UNIVERSITY OF CALIFORNIA, RIVERSIDE

PARKING STRUCTURE 1

Final Initial Study/Mitigated Negative Declaration

Section 2.0 Public Comment Letters and University Responses

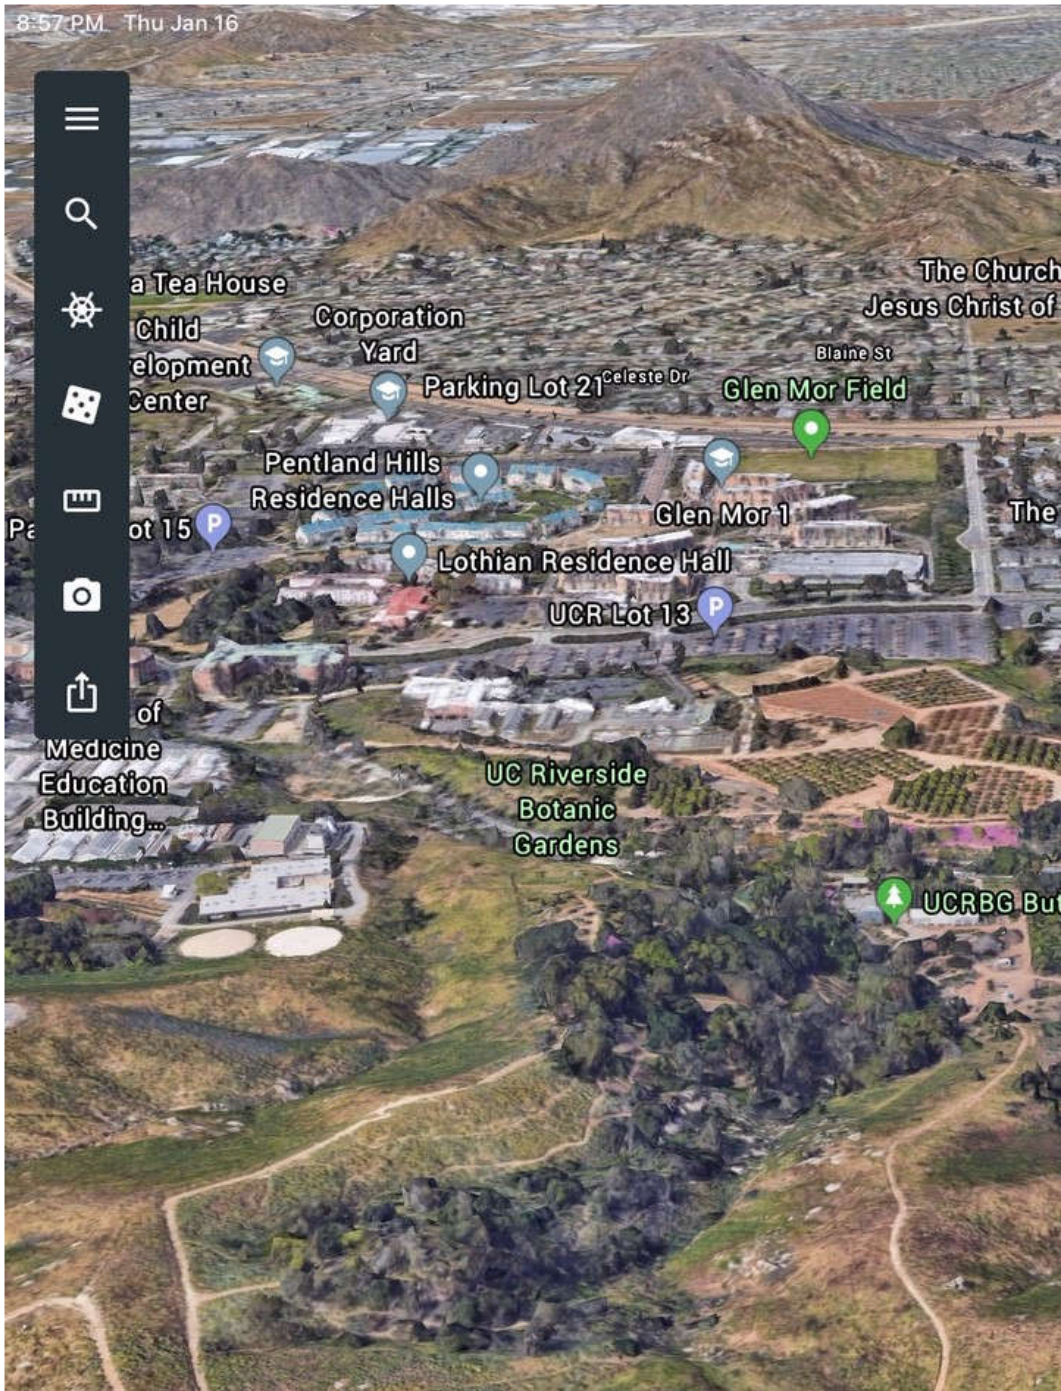
3. The project blocks a wildlife corridor that runs going north of Coyote Hill, along the eastern property line of the campus, through the Botanic Gardens and campus research groves, across the open parking lot, north up Valencia Hills Drive, connecting to the arroyo/blue line stream between Glen Mor 1 & 2, and then up to the Metrolink right of way.

Bobcat, foxes, burros, raccoon, possum, deer, and more, have been observed traversing this wildlife corridor.
